## Product Change Notification - SYST-24WWIL685

ERRATA - dsPIC33EPXXX(GP/MC/MU)806/810/814 and PIC24EPXXX(GP/GU)810/814 Errata

## dsPIC33EPXXX(GP/MC/MU)806/810/814 and PIC24EPXXX(GP/GU)810/814 Family Silicon Errata and Data Sheet Clarification

**FIGURE 1: SIMPLIFIED BEHAVIOR**

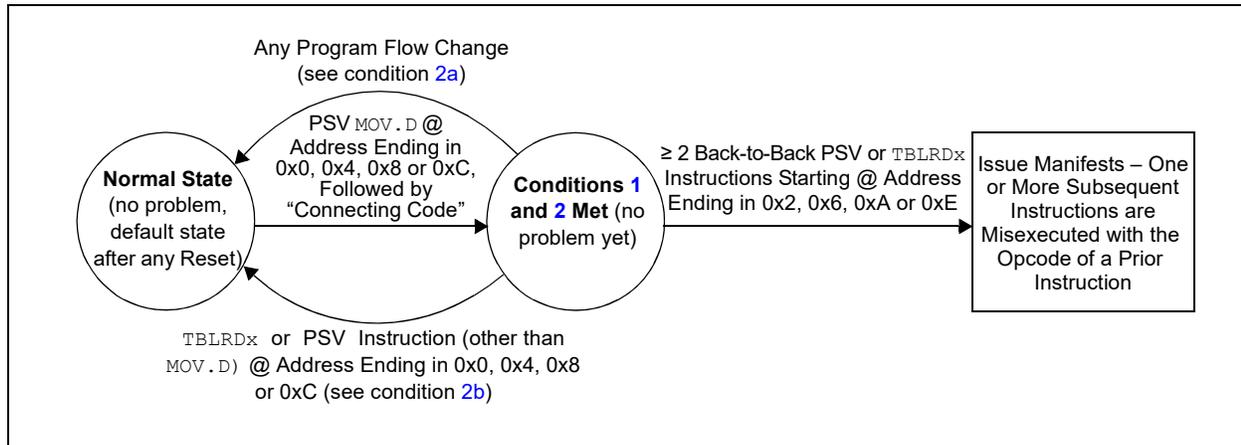
3.	≥ 2 back-to-back PSV or <code>TBLRDx</code> instructions are executed (following the code of condition 2), where the first of the back-to-back instructions is located at an address ending in 0x2, 0x6, 0xA or 0xE.

Figure 1 provides an example of the effective behavior.

1. All instances of PSV `MOV.D` can be replaced with two PSV `MOV` instructions instead. Non-PSV `MOV.D` instructions acting on RAM/SFRs do not need to be modified; or
2. If not already present, a program flow change instruction (such as `BRA $+2`) can be inserted above back-to-back data Flash read sequences; or
3. Back-to-back data Flash read instruction sequences can be broken up by inserting a non-Flash read instruction (such as a `NOB`) in between the Flash read instructions; or
4. The alignment of the code can be shifted to avoid the required opcode location addresses.

C code built with MPLAB® XC16 Compiler, Version 1.32, or later, implements the work around by default. However, if the application uses Assembly language routines, these should be manually modified to implement the work around. Additionally, if precompiled libraries are used, these should be built with XC16 Version 1.32 or later. For additional information, please visit: [www.microchip.com/erratum\\_psrds\\_psrds](http://www.microchip.com/erratum_psrds_psrds).

**FIGURE 16-2: HIGH-SPEED PWM MODULE REGISTER INTERCONNECTION DIAGRAM**

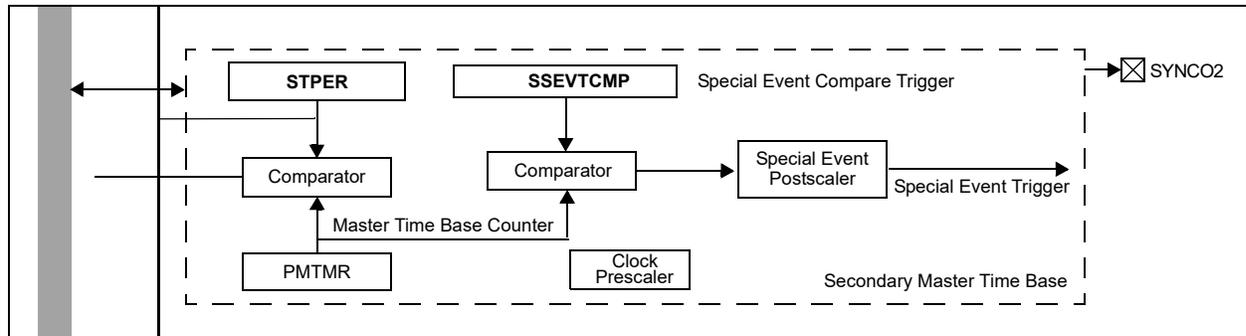
**16. Module: High-Speed PWM Module (dsPIC33EPXXX(MC/MU)8XX Devices Only)**

In **Figure 16-2: High-Speed PWM Module Register Interconnection Diagram**, the Secondary Master Time Base section has been updated. The updated text is shown in **bold** in [Figure 16-2](#) below.
